Trees Omission Plan - Sheet 2 of 8
1:100 @ A1

drawing title
Reading Borough Council
Wensley Road
client / project

Summary of Total Tree Numbers - Phase 1

Overall reduction 30 trees

Trees Omission Plan - Sheet 3 of 8

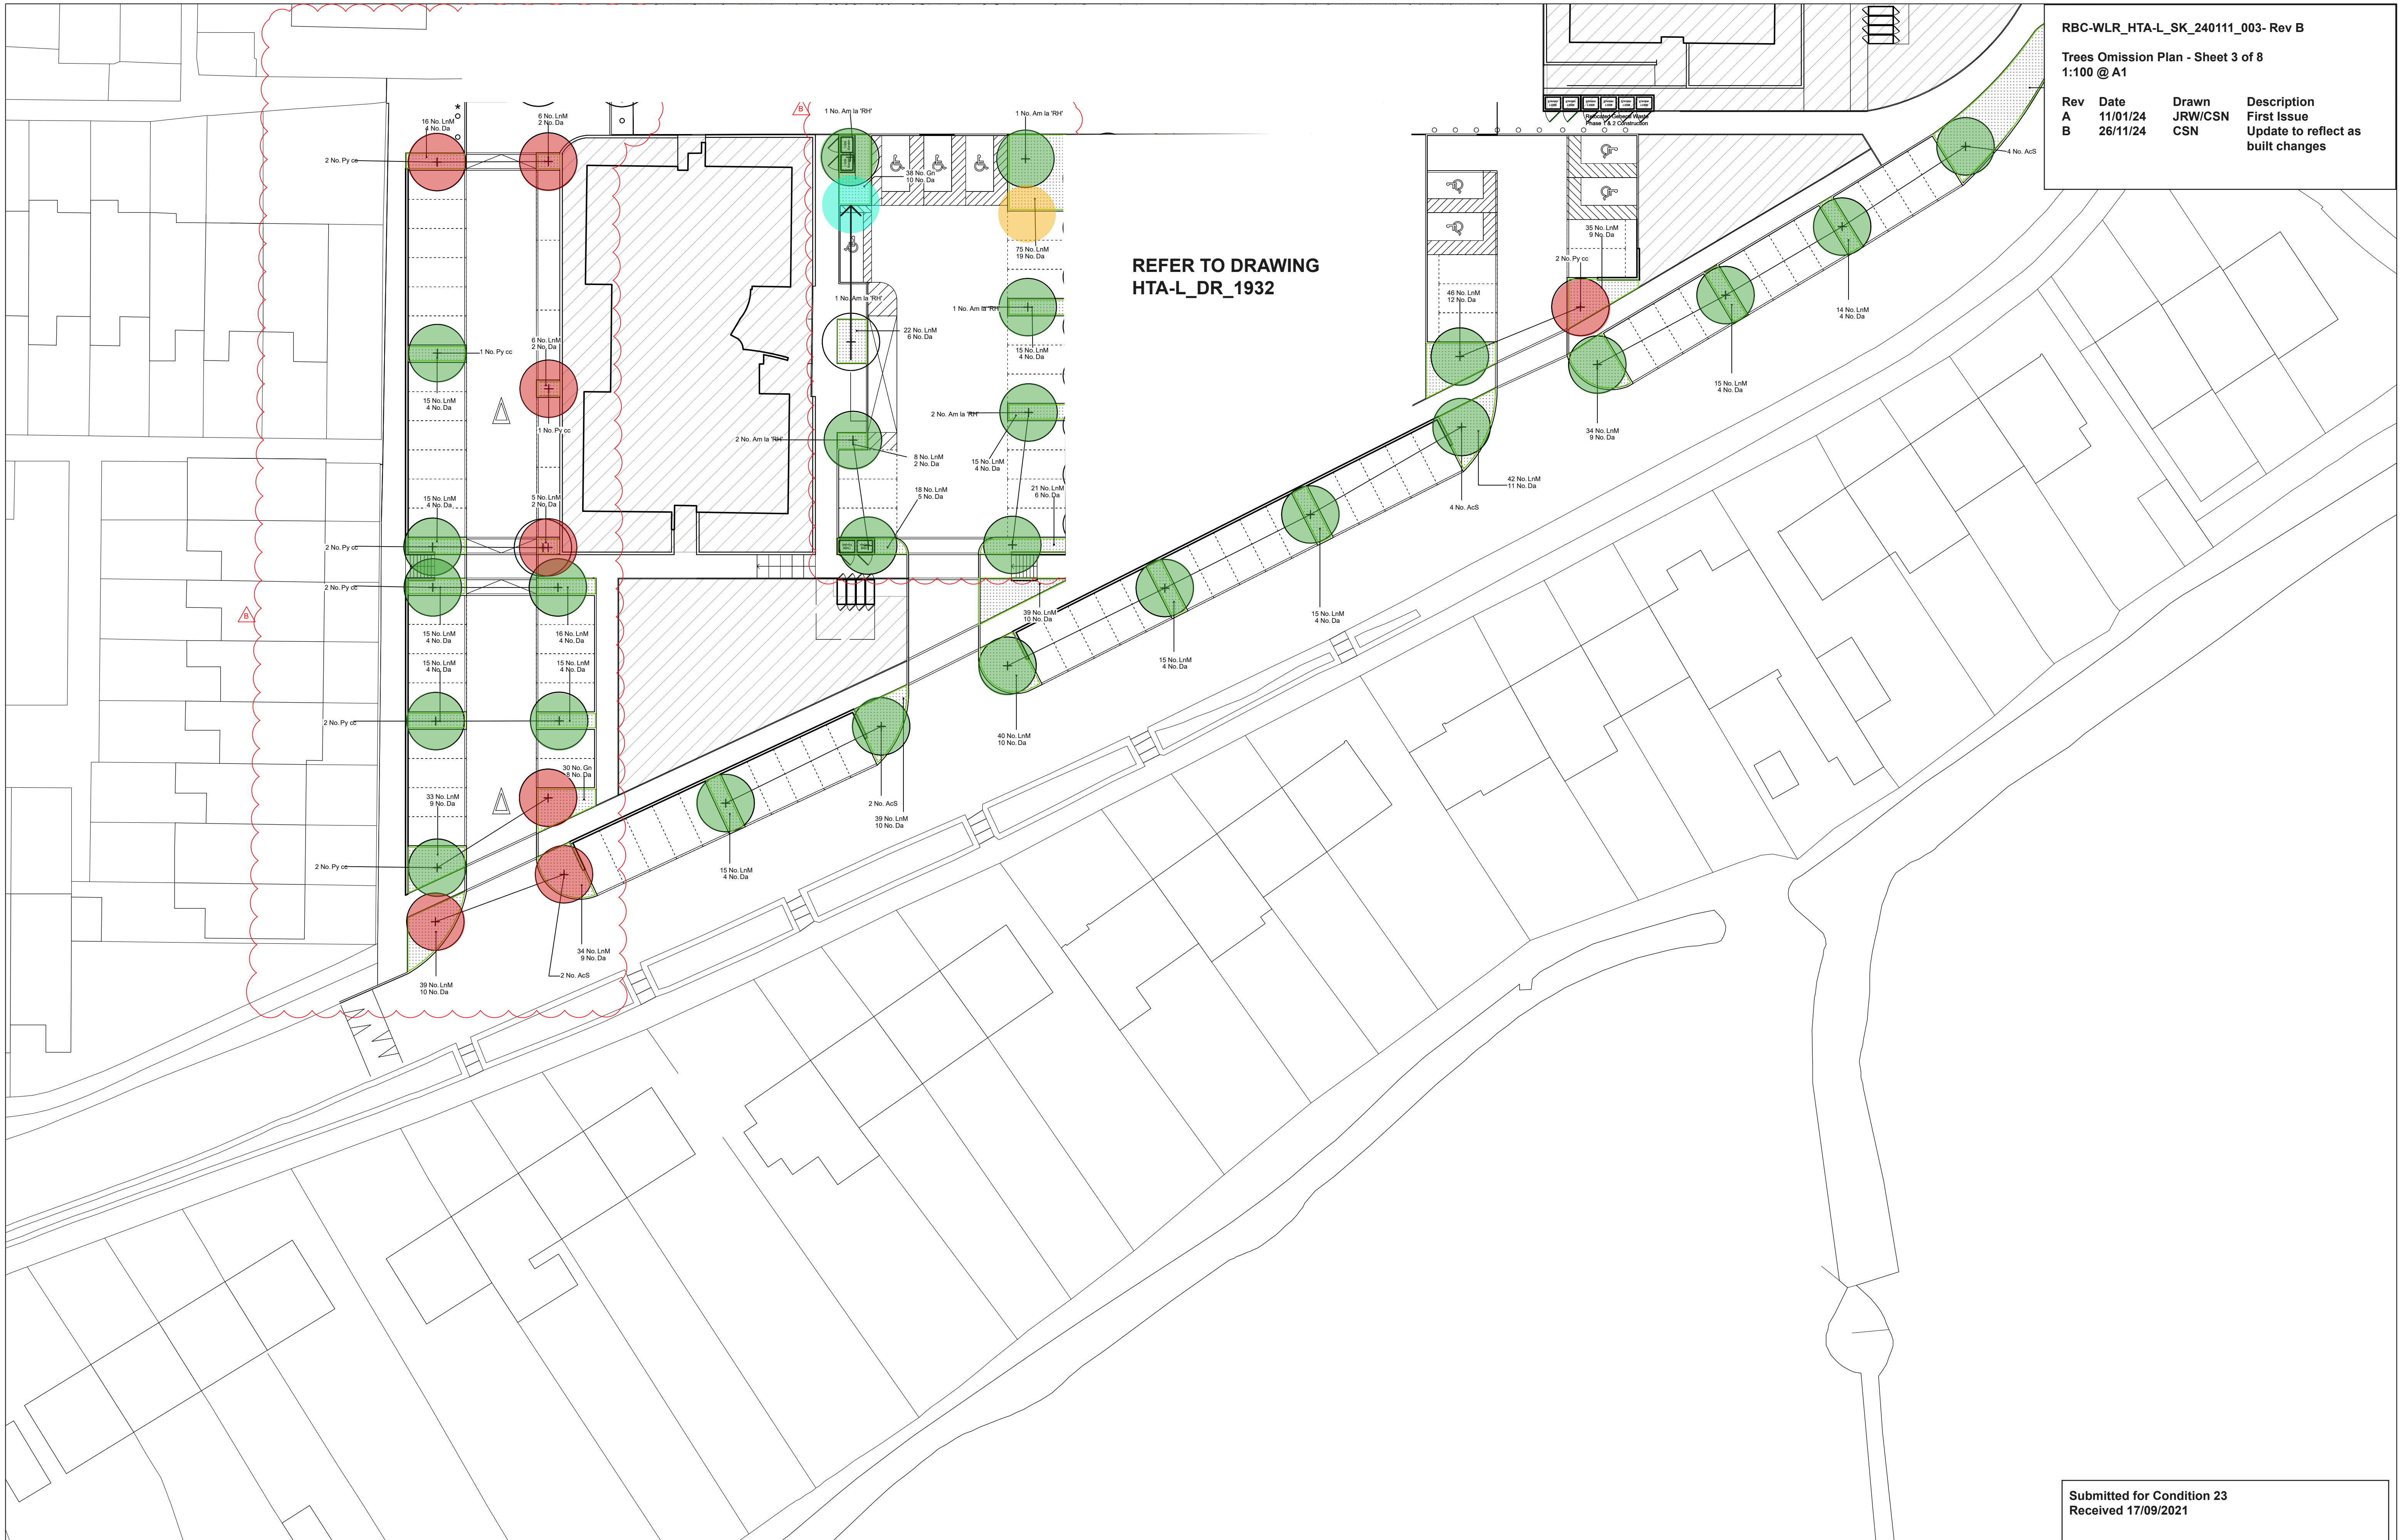
Update to reflect as built changes

Condition 23 Total - 34no trees

NMA Total - 27no trees

25no trees - Trees to remain part of proposals submitted in NMA

1no trees - Trees retained in adjusted location

1no trees - Trees additional to NMA plans

8no trees - Trees omitted from NMA plans

Trees Omission Plan - Sheet 7 of 8
1:100 @ A1

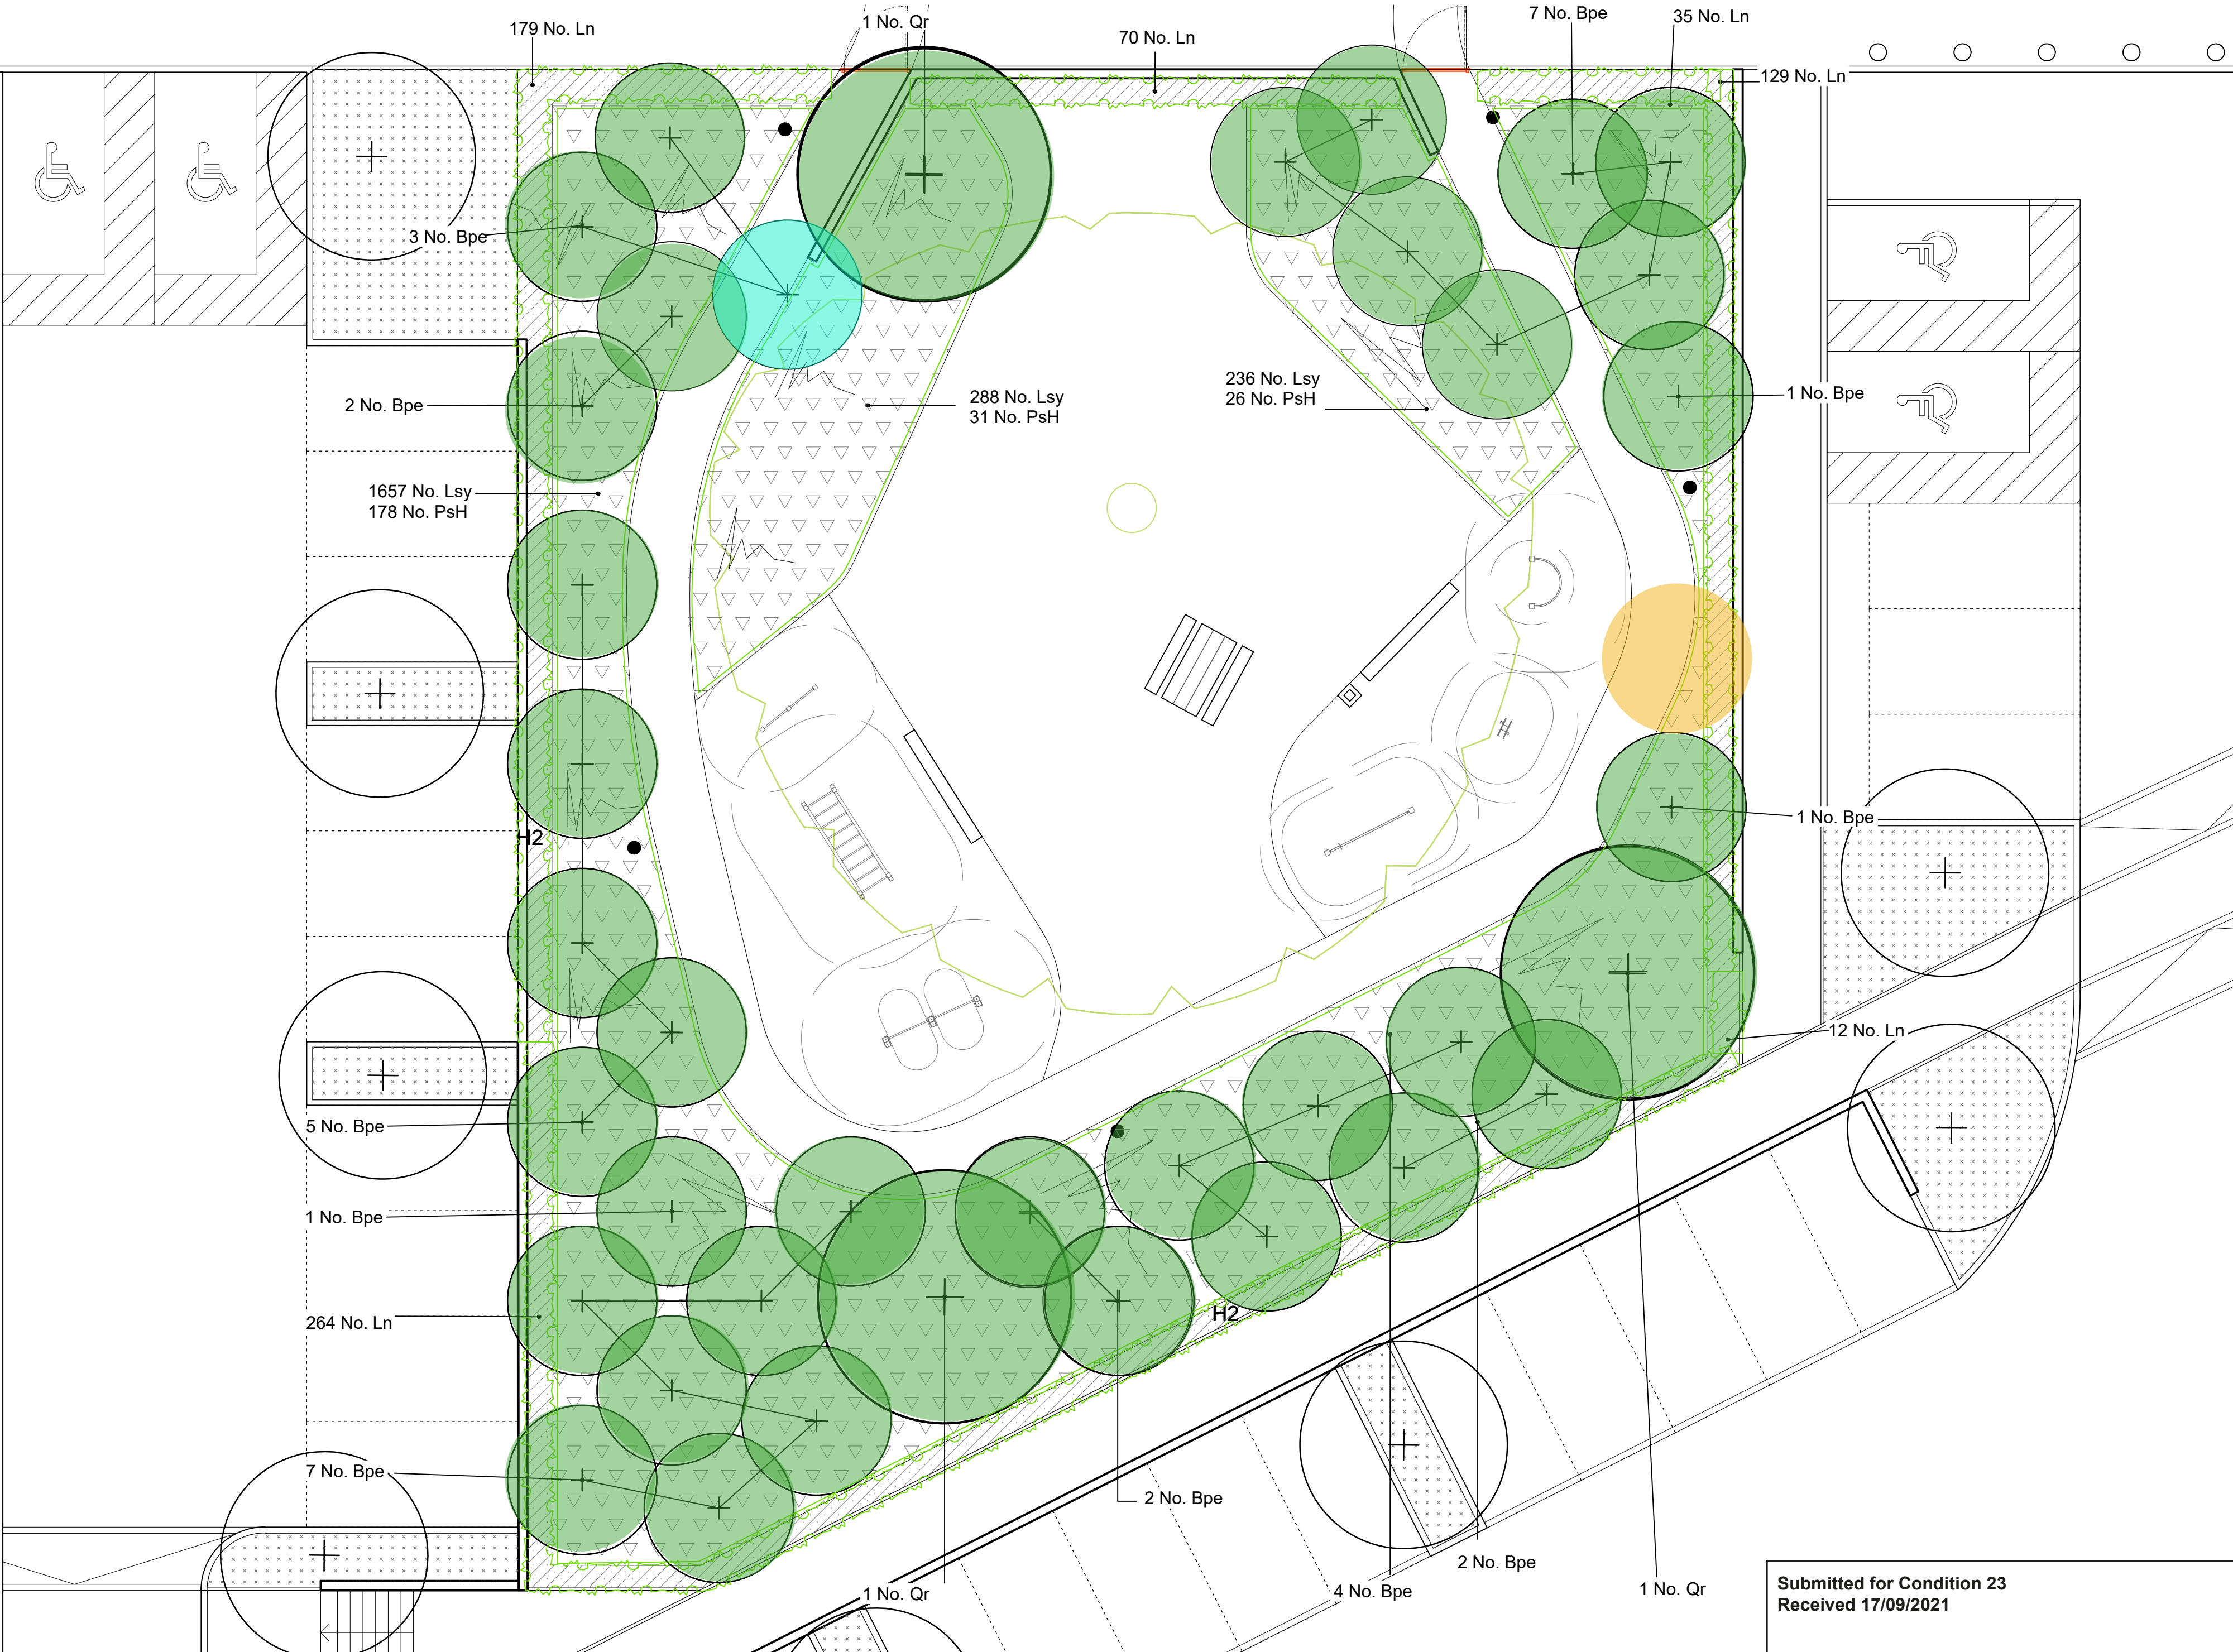
Rev	Date	Drawn	Description
A	11/01/24	JRW/CSN	First Issue
B	26/11/24	CSN	Update to reflect as built changes

Condition 23 Total - 38no trees

NMA Total - 39no trees

37no trees - Tree to remain part of proposals submitted in NMA

1no tree - Additional tree

1no tree - Tree retained in adjusted location

Detailed Planting Plan 2 of 2
drawing title Wensley Road, Reading

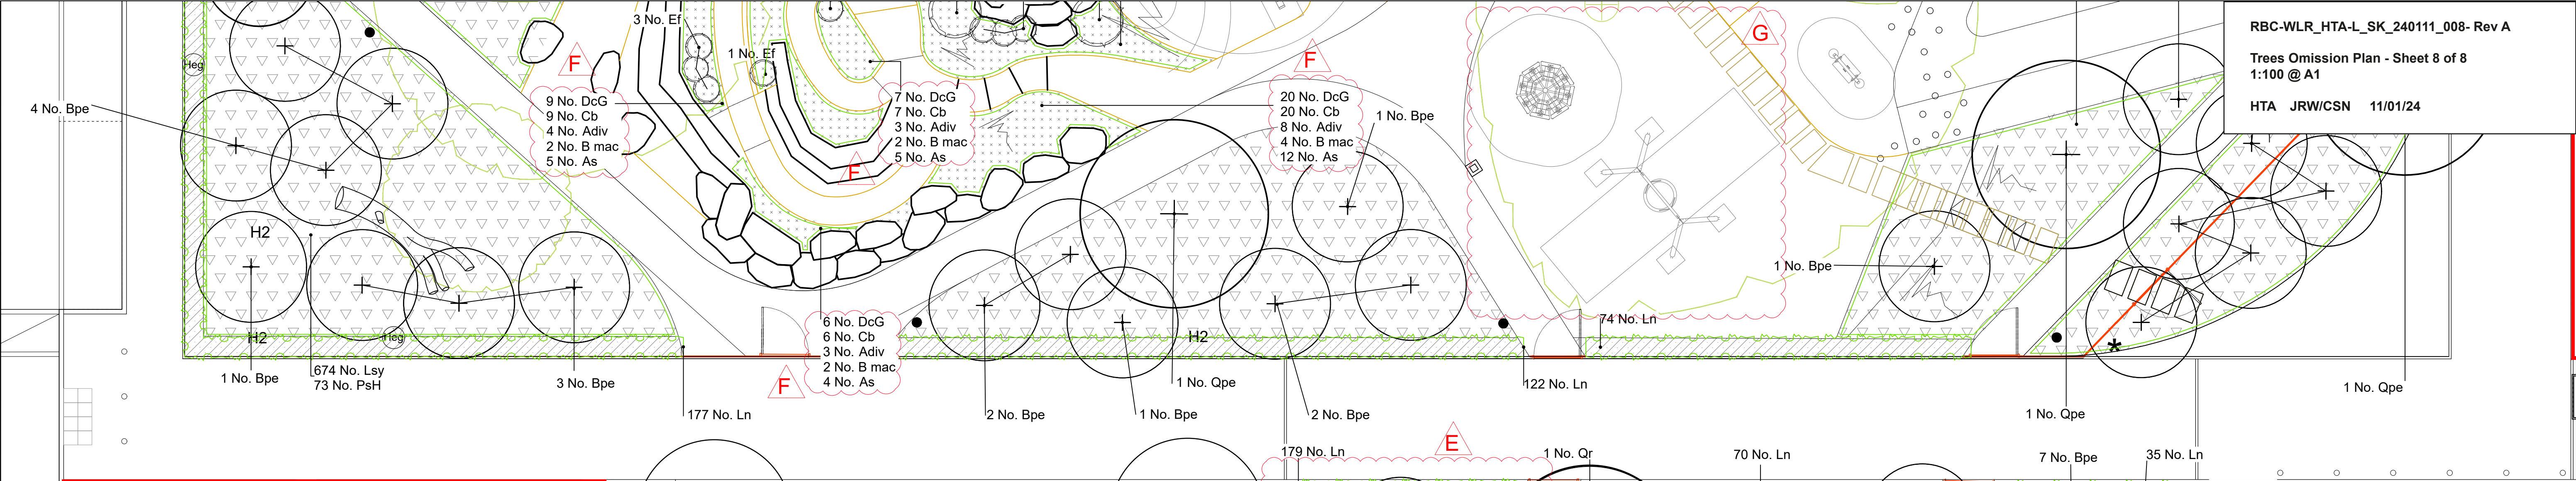
- Legend
- Revisions:
- Minor change to tree location
 - Update to planting schedule, species and densities
 - Update to background, toddler swing changed to basket swing
